LAND SOUTH OF BURBAGE, BURBAGE - SITE LAYOUT

National Highways Planning Response (NHPR 22-12) Formal Recommendation to an Application for Planning Permission

Project:	P21-390 Land at Burbage Fields Farm, Bullfurlong Lane, Burbage		
Subject:	Land at Burbage Fields Farm (application ref: 24/00083/HYB) Response to National Highways Planning Response (NHPR 22-12)		
Prepared by:	Jake Blay – Graduate Transport Planner	Date:	25/04/2024
Authorised by:	Andy Miles – Principal Transport Planner	Status:	S2 - Information
Document Ref:	21390-RLL-24-XX-TN-D-5015	Revision:	P01

Planning Application Number: 24/00083/HYB

Figure 2: Extent of Personal Injury Collision study area included in Appendix 3 of Rodgers Leask Limited Transport Assessment (TA), Revision P07, dated November 2023.

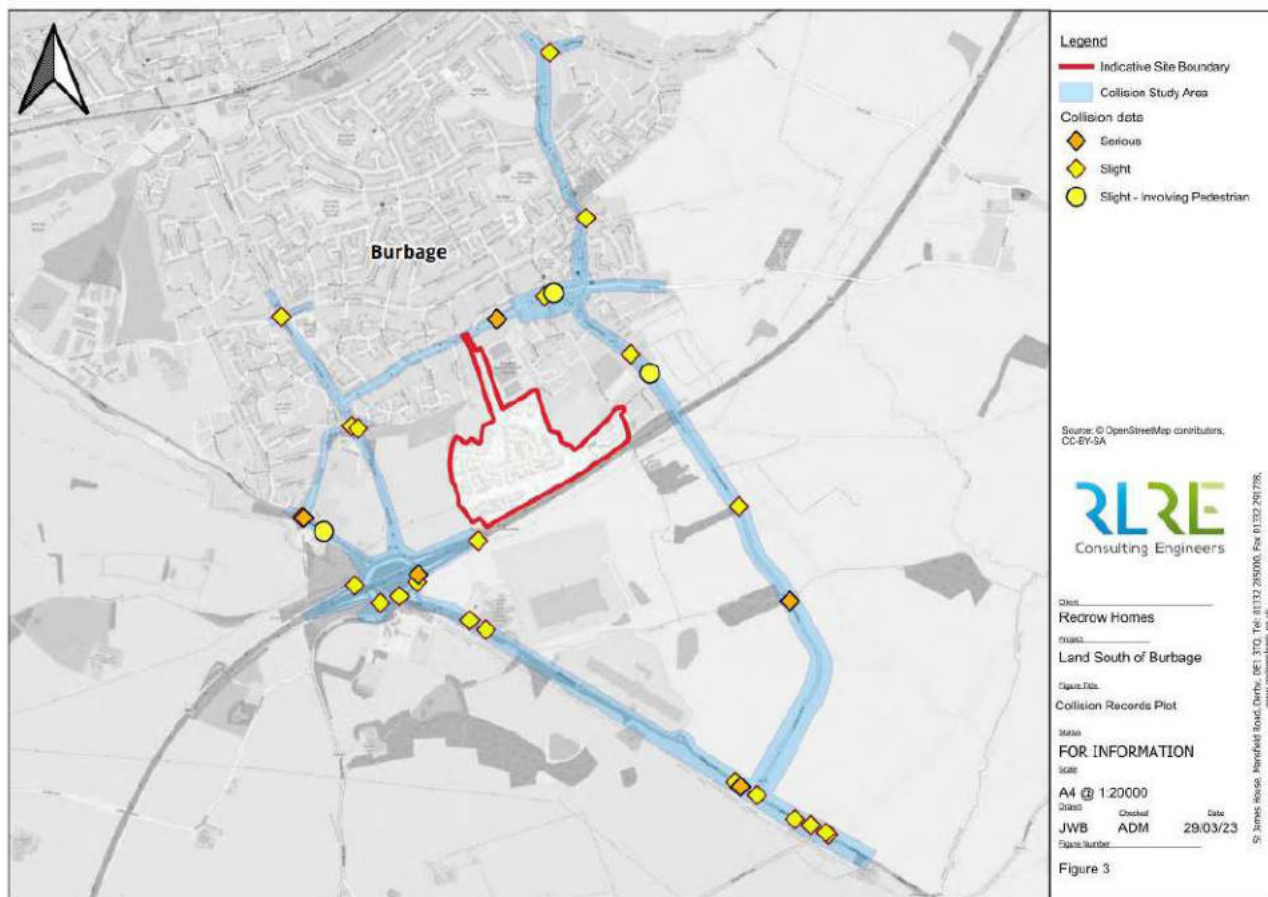
The PIC data from Leicestershire County Council has been considered for the period between 1 January 2018 and January 2022. The applicant has identified 28 PICs on the Leicestershire network in the study area. To understand the current situation with the collision data the applicant should contact LCC for the latest PIC data and submit for review.

- 3.4.1 The submitted TA included collision data from January 2018 - January 2023. As requested by LCC Highways, the latest available collision data has been purchased from the Network Data & Intelligence (NDI) team. The data covers the period January 2019 – December 2023.
- 3.4.2 This data includes additional collision records observed between the period January 2023 – December 2023. Three new collisions were recorded within this time period. **Figure 1** provides the location of these collisions in the context of

- 3.4.6 The updated collision record plot showing all collisions within the study area from January 2018 – December 2023 can be seen in **Figure 2**.
- 3.4.7 It can be concluded from review of the additional collision data that the findings of the submitted TA are unchanged. It is considered that there are no existing highway safety concerns within the study area which would be exacerbated by the development proposals.

Graph 1: Rugby Road Northbound Approach Queue Lengths by Lane – AM Peak Hour

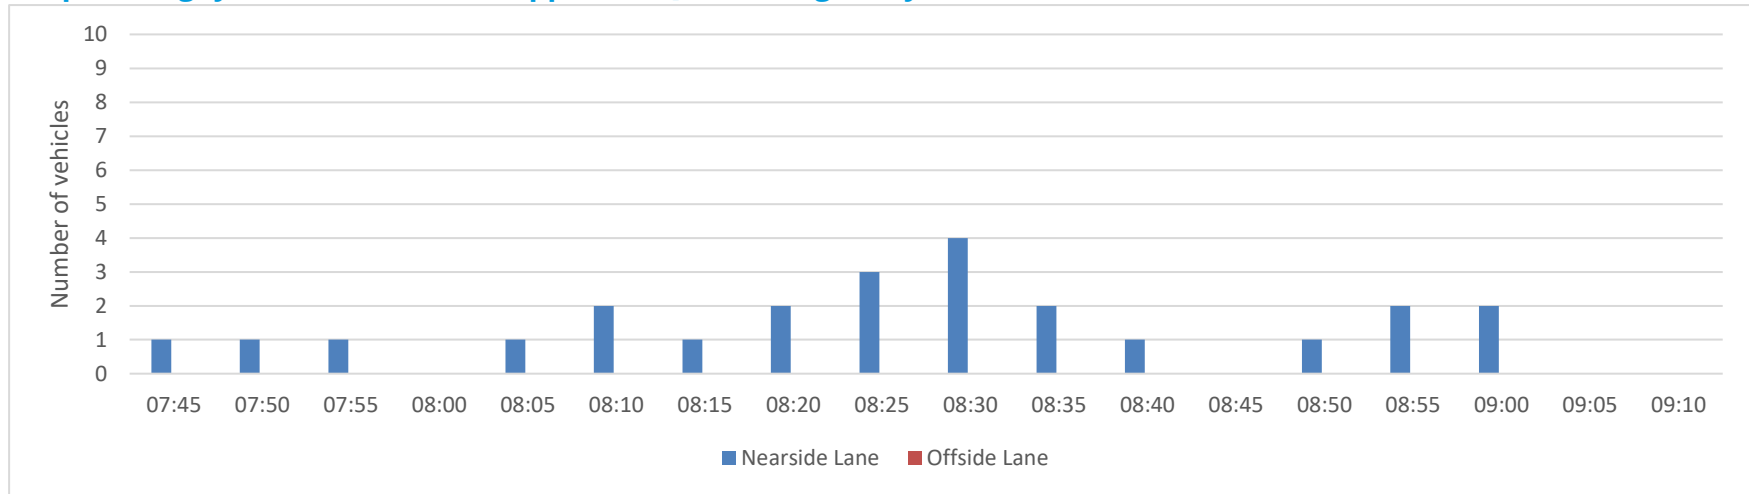
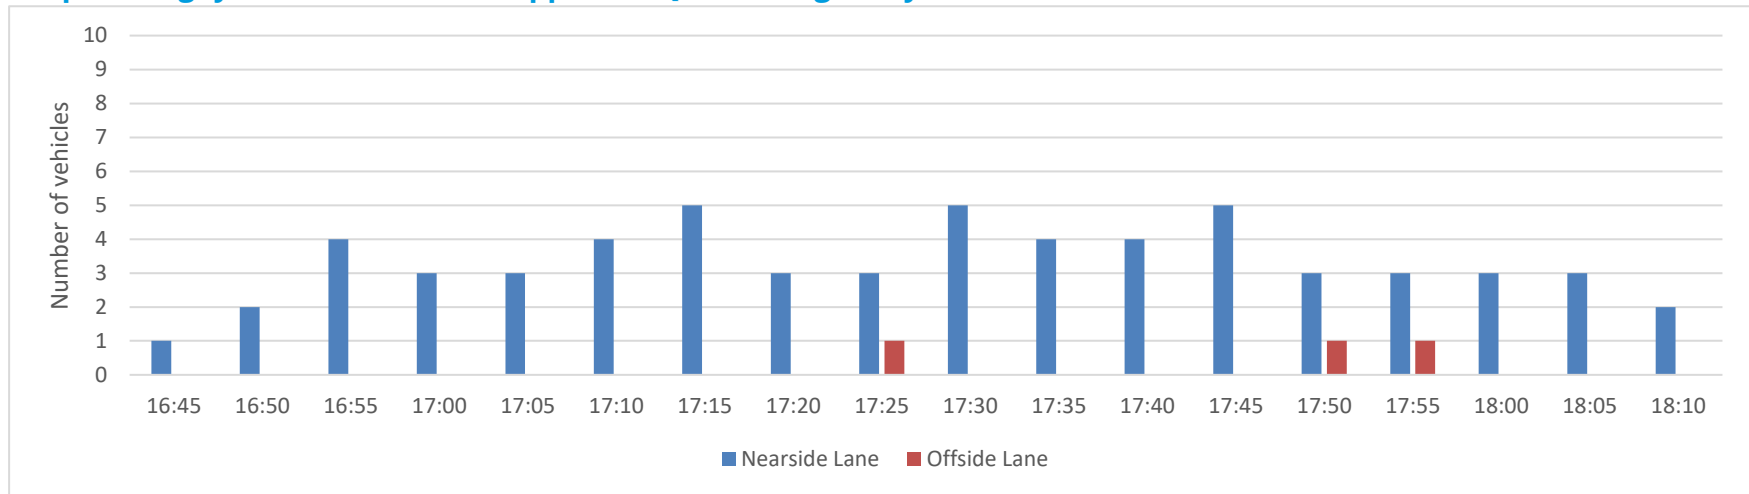
- 3.3.2 RL have previously collected queue length data at B4109 Rugby Road / Canberra Way Roundabout, recorded in 5-minute intervals during the AM (07:00 – 10:00) and PM (16:00 – 19:00) peak periods on Thursday 29th June 2023. Queue length data by lane on the B4109 Rugby Road northbound approach has been examined to determine the extent of queuing per lane which in turn gives an indication of peak hour lane usage.

- 3.3.3 The maximum recorded queue lengths within every five minute segment in the AM peak hour and the PM peak hour for both lanes of the B4109 Rugby Road northbound approach can be seen in **Graph 1** and **Graph 2** respectively. The full queue length survey data is available in **Appendix J**.

- 3.3.4 The queue length data shows that queuing is consistent within the nearside lane with no queuing in the offside lane observed in the AM peak hour and identifies only three 5-minute segments with queuing in the offside lane in the PM peak hour
- 3.3.5 It is considered that the queue length data indicates unequal lane usage on the B4109 Rugby Road northbound approach to the roundabout however, the recorded queuing in the nearside lane is considered low in both peak hours.
- 3.3.6 A comparison of the modelled queue lengths against the observed average queues in the AM and PM peak periods has been provided below in **Table 5**.

Figure 1: Approximate priority junction provision on single carriageway roads based on flows only reproduced from Figure 2.3.1 of CD 123: Geometric design of at-grade priority and signal-controlled junctions

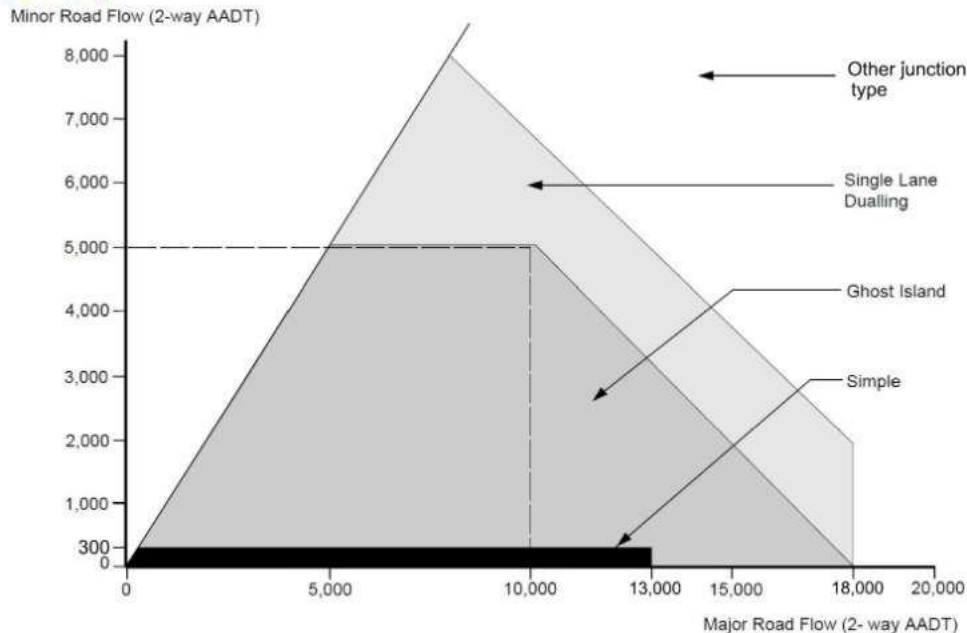
The applicant has quoted 400 two-way movements on Coventry Road in the AM-PM peaks, but Annual Average Daily Traffic (AADTs) are needed to use the chart in DMRB CD123 in Figure 1 below. The predicted trip generation figures seem to point to something more substantial than a simple junction being needed based on the AADT on Coventry Road which are presented in the traffic flow diagrams on the LPA website on 23 January 2024 and the likely AADT on the minor road which will serve the proposed development.

The applicant would need 8.5m for the carriageway (2.5m turning lane and 3m running lanes), plus a 2m footway. Following a review of the drawings which have been provided there would not be space to fit in this 10.5m total corridor width. Therefore the LHA would agree with the applicant that there would be insufficient room within the highway to fit in a ghost island right turn lane. However, the effect on pedestrians crossing on Coventry Road could be mitigated by providing traffic islands with tactile paving.

Notwithstanding this, the applicant is therefore required to consider the access proposals and submit revised proposals accordingly.

Appendix G: Coventry Road Site Access Drawing

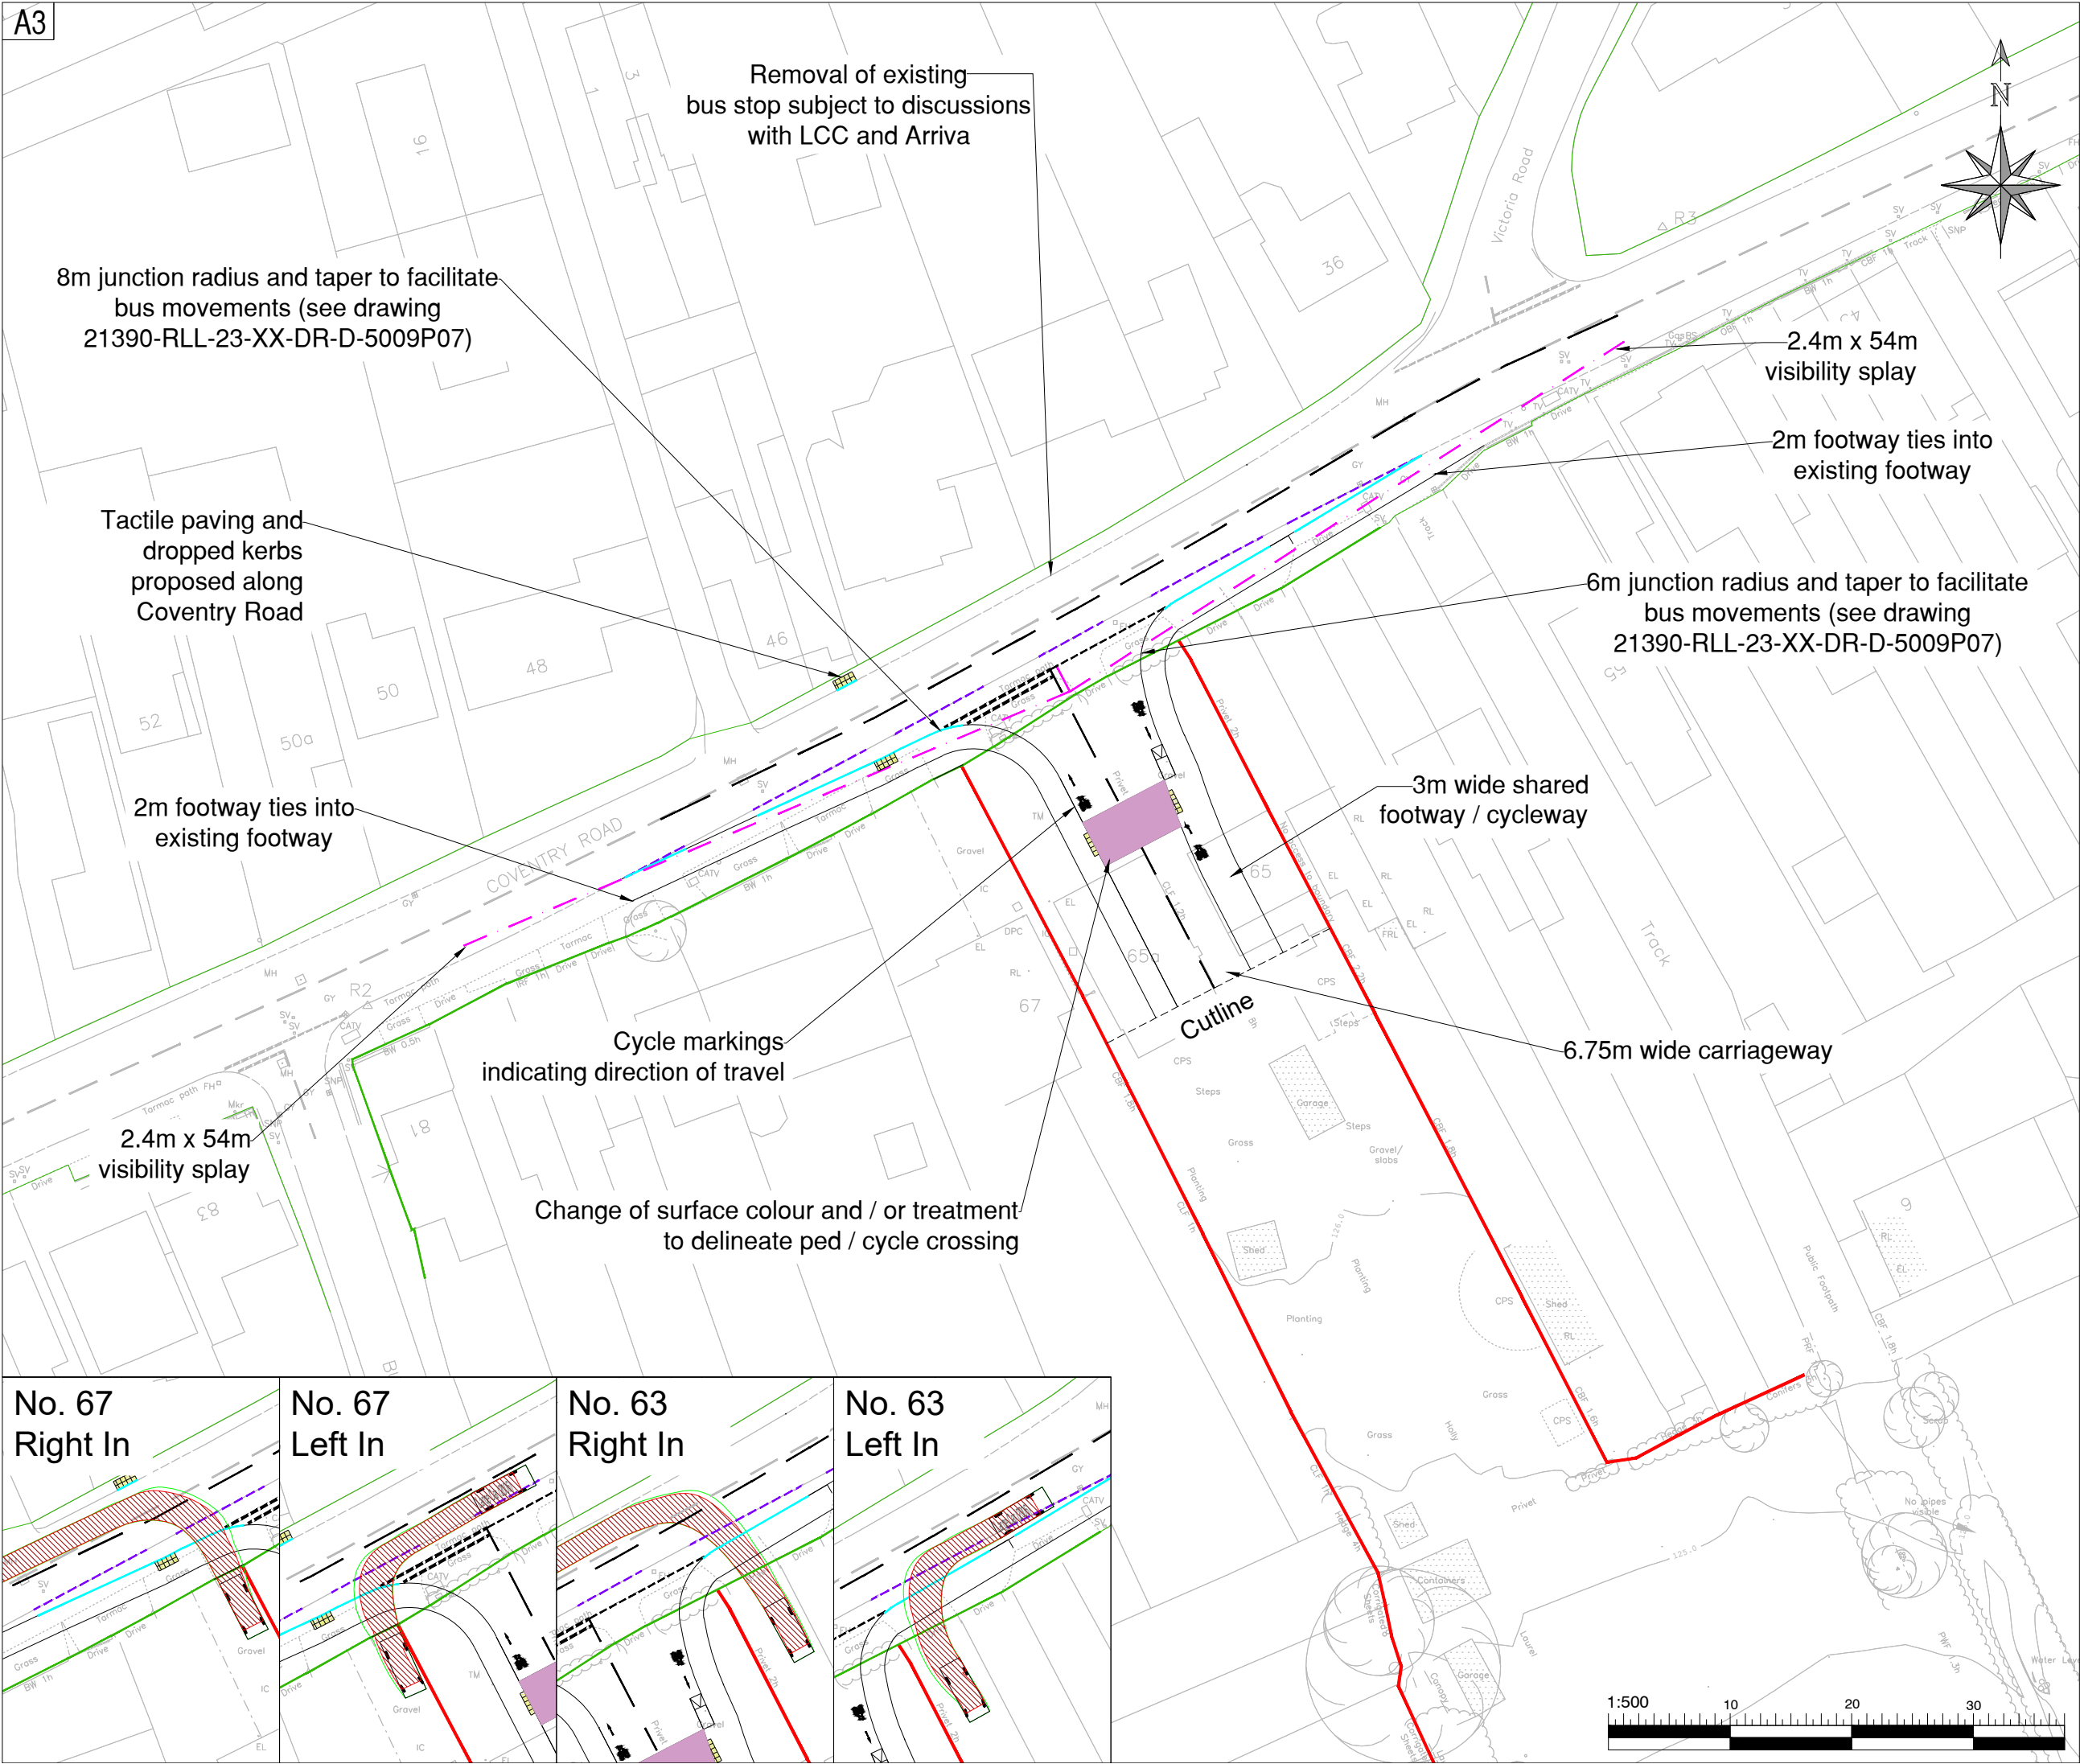
After a review of the revised drawing 21390-RLL-23-XX-DR-D-5008 Revision P06, the LHA would advise the following:
